Product Change Notice (PCN)

Subject: Add Back-End factories, materials, and change packing material of Tape & Reel for RX113 LQFP package products

Publication Date: 12/24/2021

IMO-AB-21-0076

14x14mm 100pin LQFP package drawing (Addition)

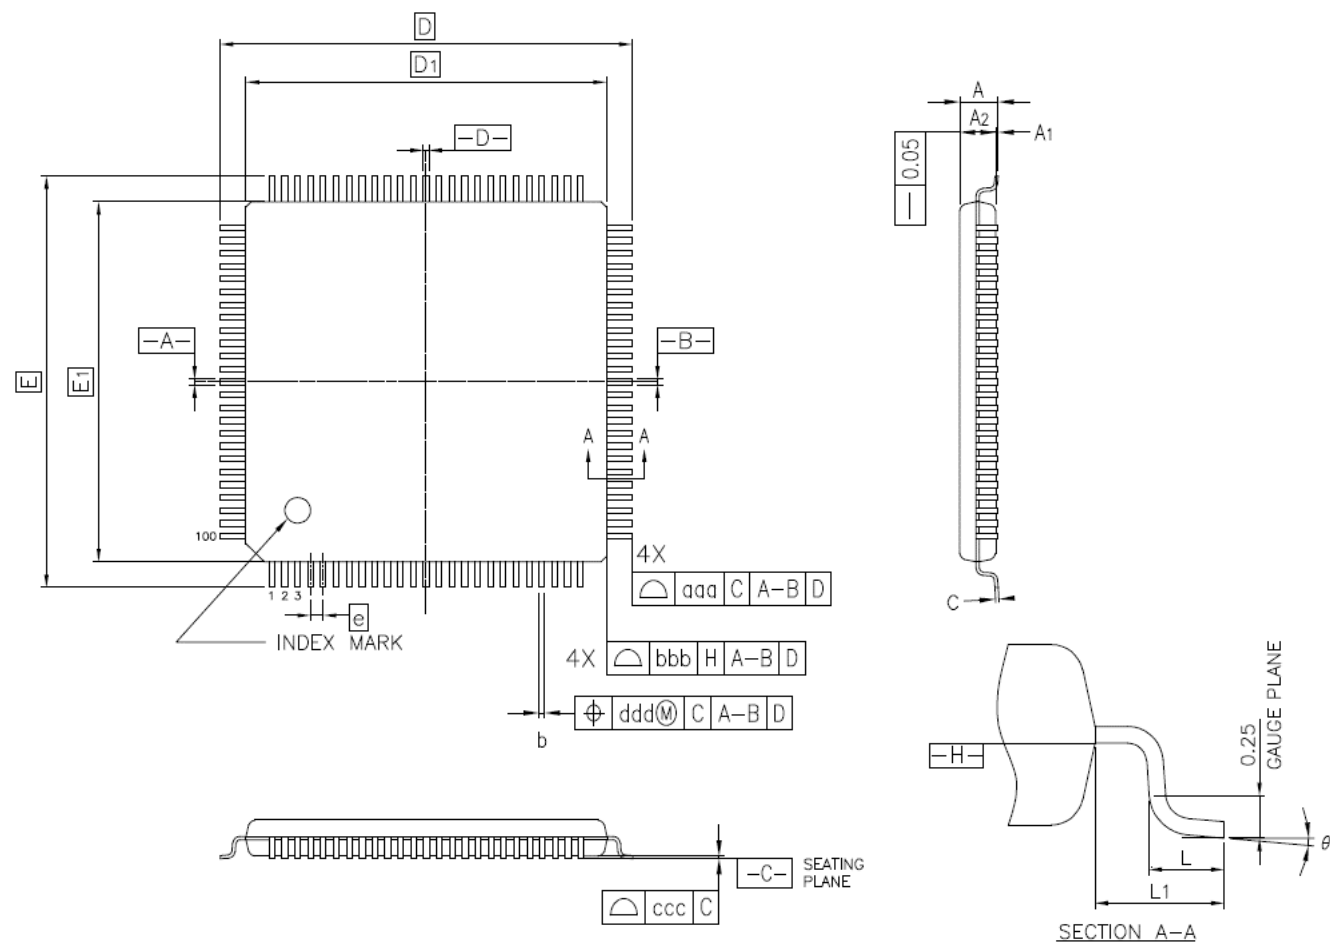
*The dimensions are equivalent to the current ones.
The difference in the numerical value is because the part specified as the dimension is different.

Current (W:32mm)

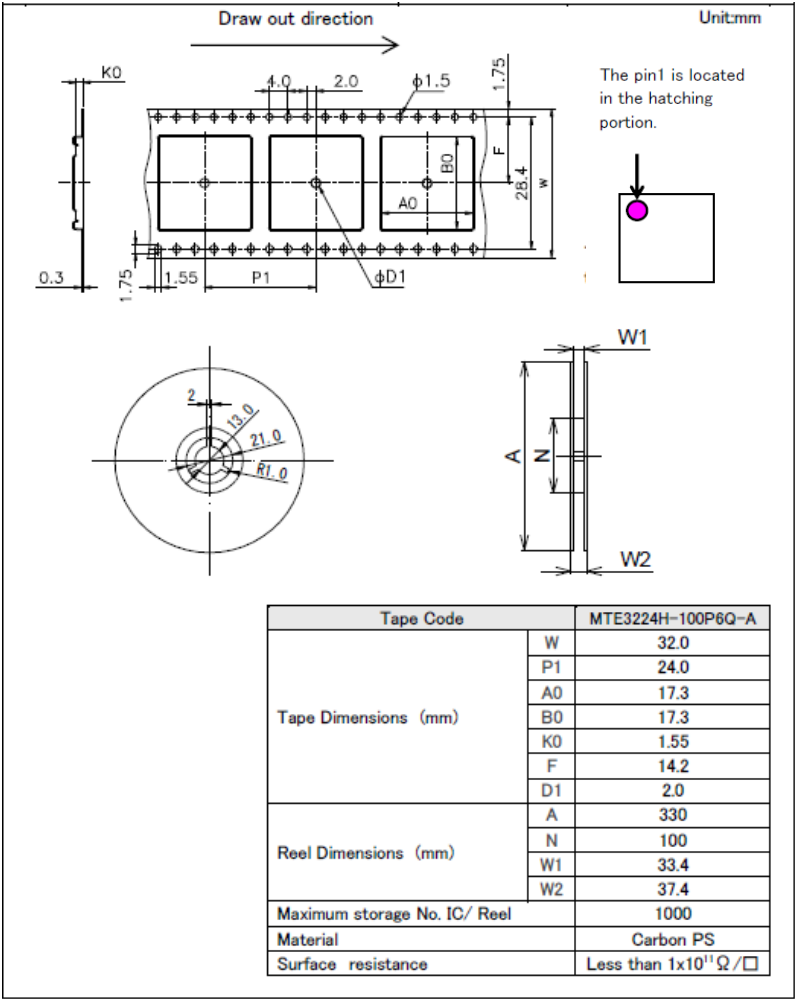
3) Change an emboss tape width:

According to the change an emboss tape width, we also need to change cavity width, cavity depth, sprocket hole, dimension between center of sprocket hole and cavity, reel width and cover tape width.

Current: 32mm*
